**SUBJECT:** NuScale Power, LLC Supplemental Response to NRC Request for Additional Information No. 466 (eRAI No. 9482) on the NuScale Design Certification Application

## **Response to Request for Additional Information Docket No. 52-048**

**NRC Question No.:** 06.02.01.01.A-18

### **Conservatism in the NPM Initial Conditions for the CNV Safety Analyses**

**Table 6.2-2: Containment Response Analysis Results<sup>3</sup>**

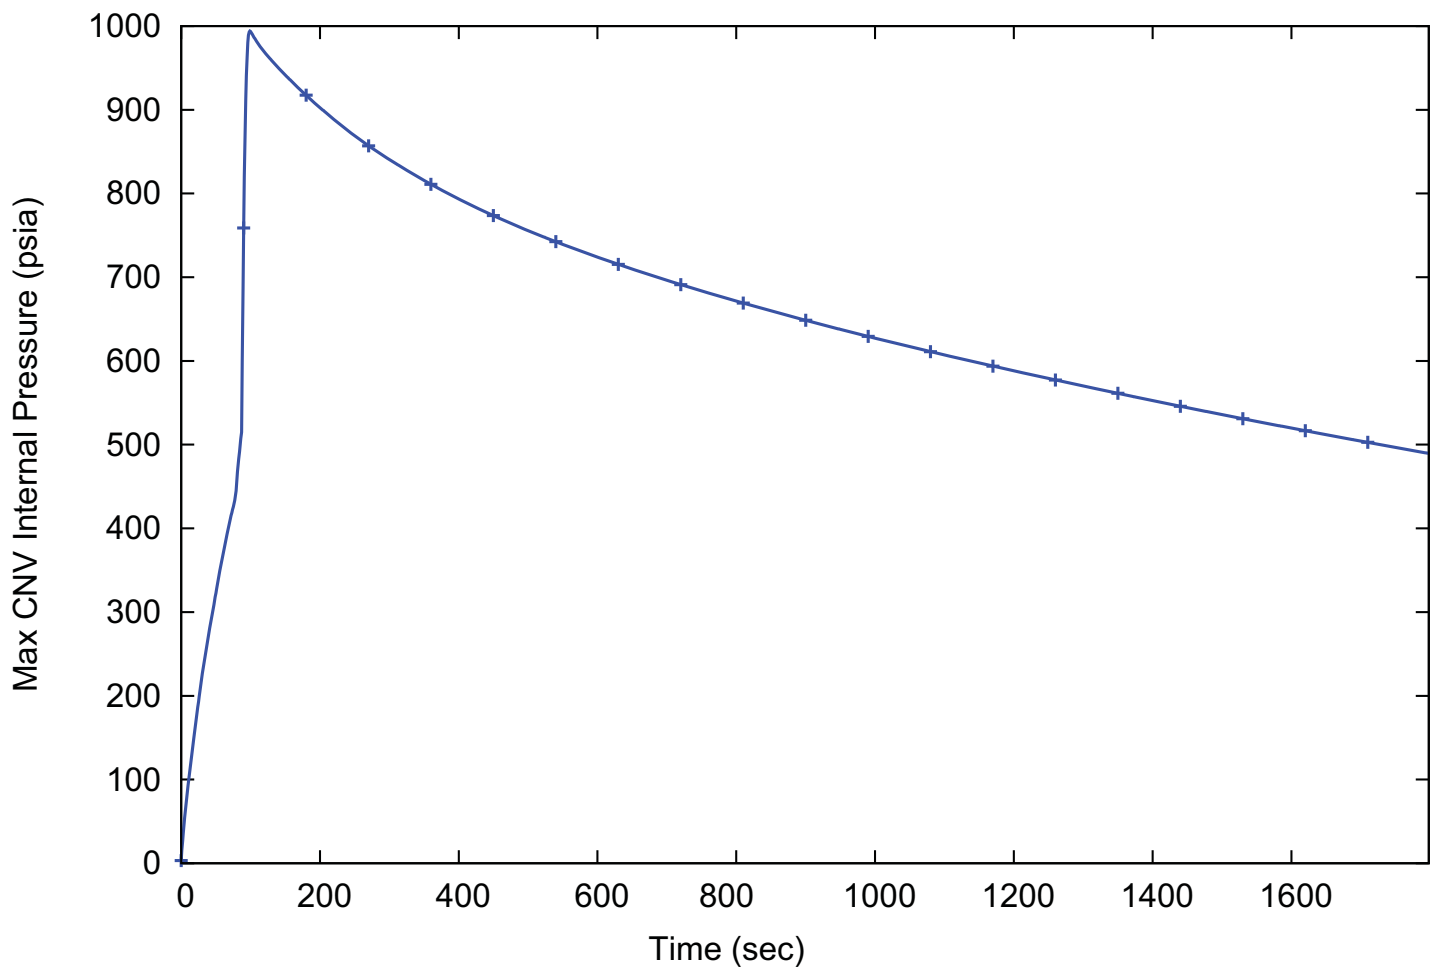
In Table 5-1 of the Containment Response Analysis Methodology Technical Report (TR-0516-49084-P, Rev. 0), the nominal CNV free volume is adjusted by {{ }}<sup>2(a),(c)</sup> percent as a conservative initial condition for the containment response analysis to account for uncertainty in design, blockage in containment by components, such as, piping, etc. However, the base NRELAP5 model described in {{ }}<sup>2(a),(c)</sup> has not been updated for numerous geometry changes reported in {{ }}<sup>2(a),(c)</sup>, so it is not clear that

a {{ }}<sup>2(a),(c)</sup> percent CNV free volume adjustment is adequate and would also cover the thermal expansion of the reactor pressure vessel (RPV) under operating conditions. The staff also noted that {{ }}<sup>2(a),(c)</sup> used {{ }}<sup>2(a),(c)</sup> percent conservatism in CNV free volume but that was reduced to {{ }}<sup>2(a),(c)</sup> percent in Rev. 2. Please explain why a {{ }}<sup>2(a),(c)</sup> percent reduction in containment volume is justified for a NRELAP5 base model that may not reflect the current design. If necessary, please update the NRELAP5 base model and resubmit the updated NRELAP5 models and their results for the limiting DBEs for CRAM, as submitted in response to RAI 8783; or justify how the peak CNV pressure and temperature results remain conservative with an outdated base model. When the licensing basis containment analyses are updated, the FSAR and the decks also need to reflect the rise of initial CNV pressure from 2 psia to 3 psia, as was concluded by RAI 8793, Question 29717 (06.02.01-2).

As described by NuScale letter, LO-0819-66702, dated August 26, 2019, the results of additional ECCS valve testing at reactor operating pressure and temperature necessitated an adjustment to the inadvertent actuation block (IAB) range. The letter indicated that conforming changes to the DCA would be transmitted to the NRC for review. This supplement transmits the conforming changes reflecting the revised IAB operating range.

FSAR Sections 6.2 and 6.3, DCA Part 4, FSAR Table 6.2, and related Technical Report TR-0516-49084, Containment Response Analysis Methodology, have been revised as described in the response above and as shown in the markup provided with this response.

The peak calculated containment pressure resulting from a secondary side mass and energy release is postulated as the result of a double-ended steam line break inside containment. The analysis assumptions are documented by Reference 6.2-1, Section 5.2. ~~assumes fine CNV axial volume and radial CNV heat structure nodalization, fine reactor pool nodalization, an IAB release pressure of 1200 psid, low RCS flow and a failure of the associated FWIV to close.~~ The peak calculated pressure is listed in Table 6.2-2, 449 psia.

The peak calculated containment temperature resulting from a secondary side mass and energy release is postulated as the result of a double-ended steam line break inside containment. The analysis assumes normal AC and DC power available, and a failure of the associated feedwater isolation valve (FWIV) to close. The peak calculated temperature is listed in Table 6.2-2, 433 degrees F.
